Project Name: 502 East Atlantic Avenue

Request: Amendment to the Blanket Sign Program

SITE PLAN REVIEW AND APPEARANCE BOARD STAFF REPORT

Consideration of an amendment to the Blanket Sign Program for the property located at **502 East Atlantic Avenue**.

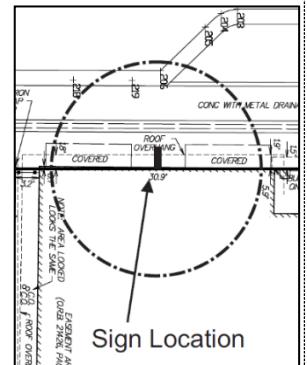
The proposed projecting sign on the west elevation (graphic at right) meets the intent of the code pursuant to LDR Section 4.6.7(E), which allows a projecting sign up to 30 SF. However, pursuant to LDR Section 4.6.7(3)(c)(8), *when a sign requires a permit and is located within an easement or right-of-way, an agreement in a form acceptable to the City Attorney shall be executed between the property owner and the City. The agreement shall be executed by the City Manager, or their designee. A performance bond or acceptable substitute guarantee may be required.* If the projecting sign is approved, a Hold Harmless agreement will need to be executed prior to permit issuance.

West Elevation

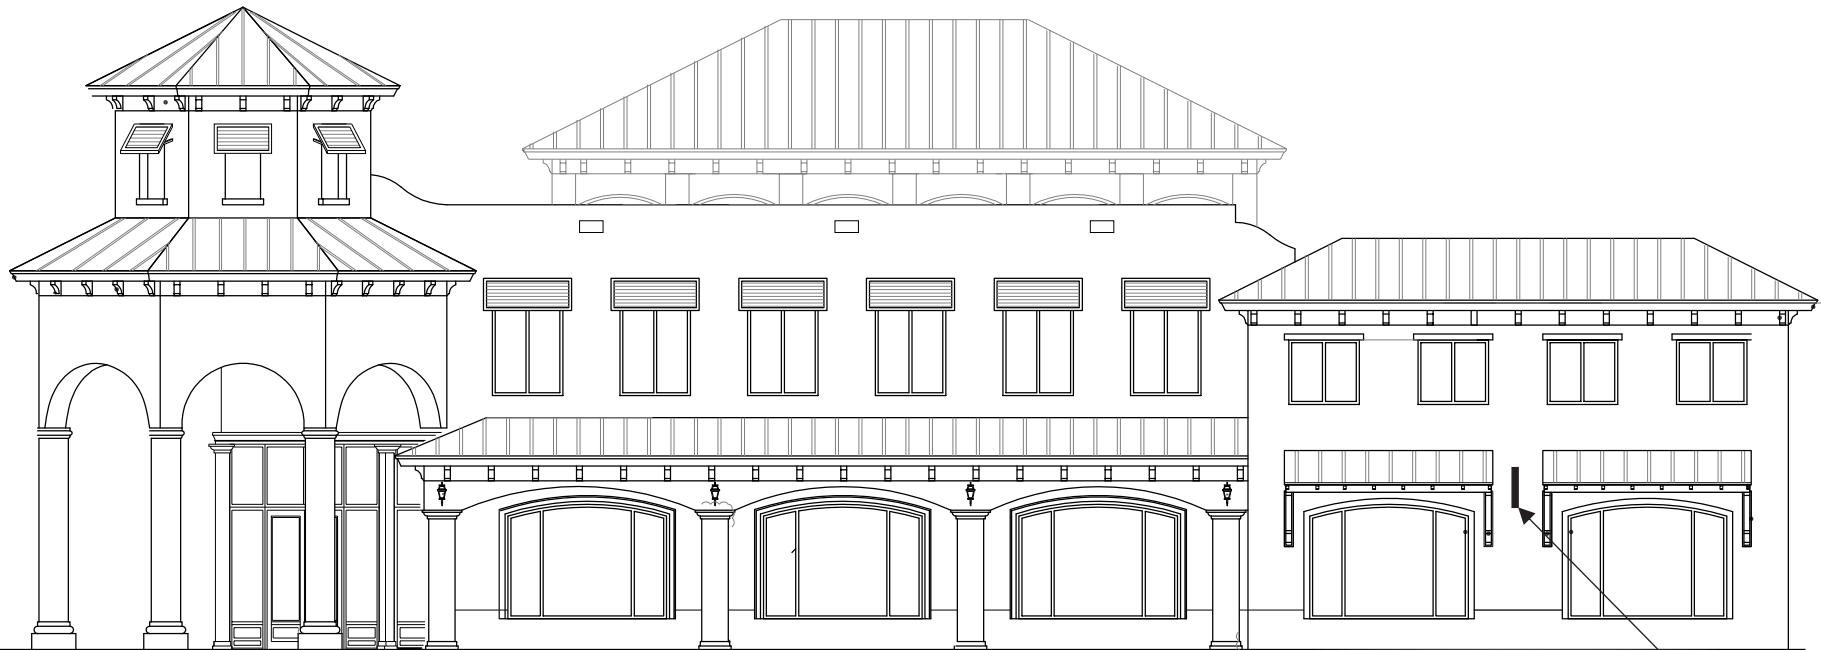
West Elevation (Costa Organic Kitchen) Approved administratively as it met the perimeters of the Blanket Sign Program and a new projecting sign 3 feet by 1 foot 5 inches for a total of 4 feet 5 inches.
